**Third Quarter 2006 Progress Report**  
Midwest Roadside Safety Facility  
Mid-States Regional Pooled Fund  
November 4, 2006

## **Pooled Fund Consulting Summary**

Midwest Roadside Safety Facility  
August 2006 – October 2006

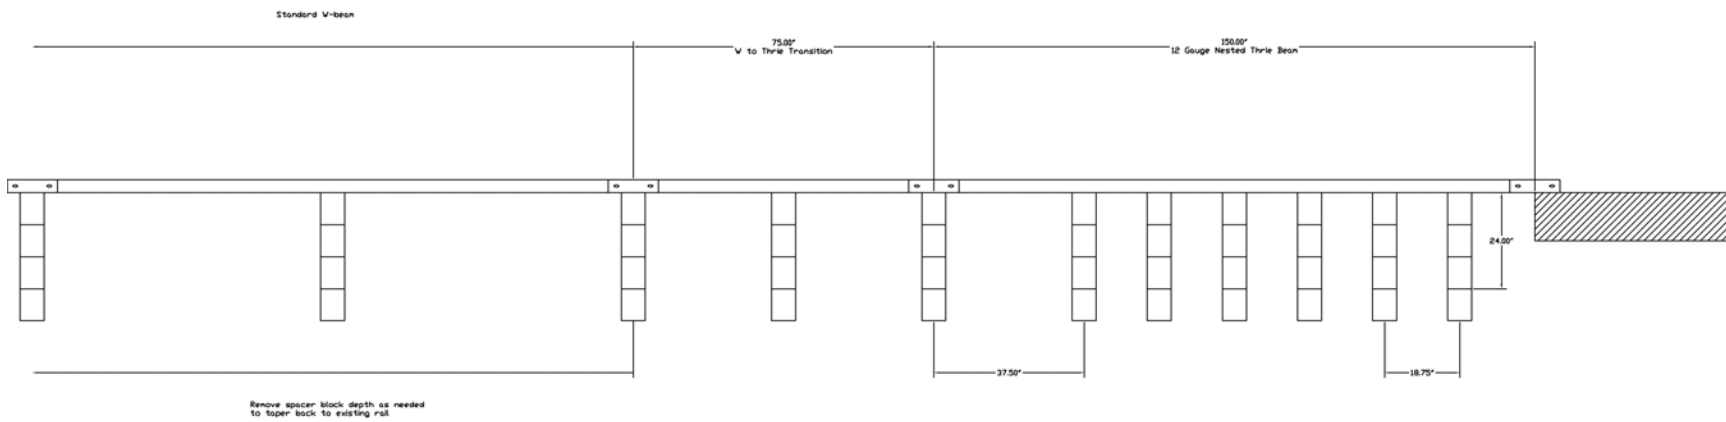
1. Can we use double blockouts in the portion where the curb is in front of the guard fence for the full length of the guard fence to bridge rail transition section? How many posts can have more than one blockout and is there a limit, ie some may want to use three blocks on several posts. I am looking into the height of the bridge rail to see if we can get thrie beam on it.

Dr Sicking asked me to look at your transition issue from the email below with regards to blockout depth and the addition of some thrie beam guardrail. I have reviewed the photos you sent and I believe we can retrofit your installation to improve it significantly. I have attached a schematic of our proposed modifications. We are basically proposing that you blockout the existing system using 24" deep spacer blocks (basically three standard 8" deep blocks in series). We have used 16" blocks on several systems in the past with no problems and we believe that 24" of spacer block is okay as well. We are also recommending that you replace the first 12'-6" section of w-beam with nested 12-gauge thrie beam. Then a W-thrie transition section would be placed between the nested thrie and the standard w-beam. This layout would make you

installation very similar to the Iowa transition developed by the Pooled Fund and would increase the safety of the installation greatly. After the W-thrie transition section, the spacer blocks could be reduced incrementally to taper the w-beam to meet the existing installation.
